90% PLAN REVIEW

Shake Shack – Oak Lawn, IL
4071 W. 95TH St.
Oak Lawn, IL 60453

National TAB
1126 Swift St.
North Kansas City, MO 64116

M703 (page 89)

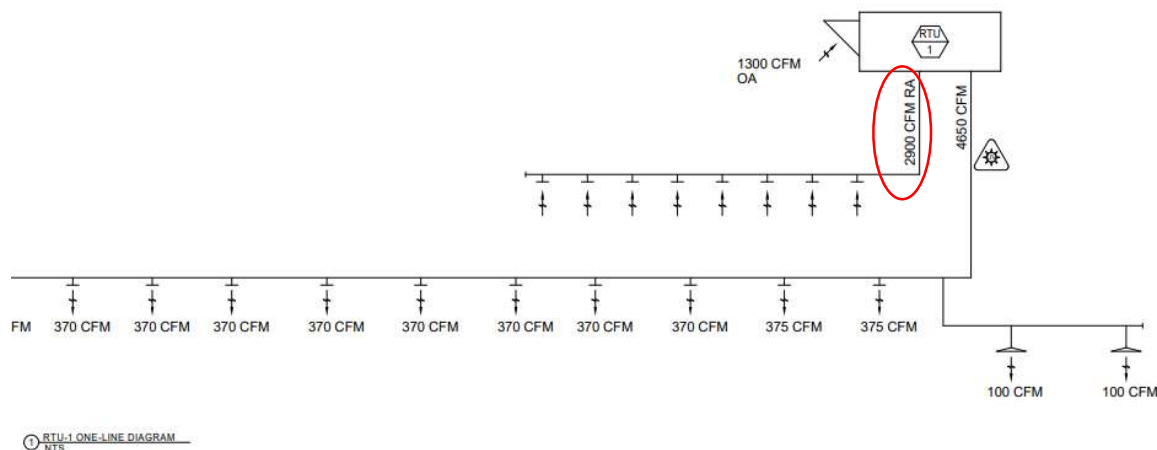
Change “Full Flood Ansul System” to Ansul’s proper terminology “Ansul R-102 Overlapping System” Not corrected

Note 1: Change “in accordance with R-102 installation manual” to “in accordance with Ansul R-102 overlapping system manual” Not corrected

Note 2: Change “wire rope” to “stainless steel cable” ” Not corrected

Add note prior to note 3: Fire suppression contractor shall have an additional trip for an onsite pretest with the general contractor, mechanical, plumbing, building alarm and electrical contractors prior to

final suppression with local AHJ. Deficiencies shall be resolved by responsible trade before the final can be schedule. Test should be conducted at 3 days (minimum) prior to scheduled final. **Not corrected** –

Add Note: All connections to the fire suppression low voltage and high voltage Ansul micro-switches must be made in a U.L rated Junction box outside of the Ansul automan compartment to keep from voiding the listing of the Ansul system. **Not corrected**

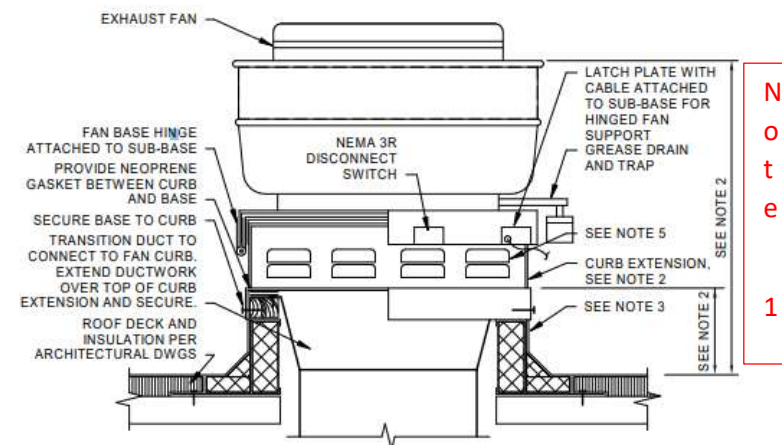
New comment: 90% review comment. M502: Change RTU-1 Return air from 2,900 to 3,350
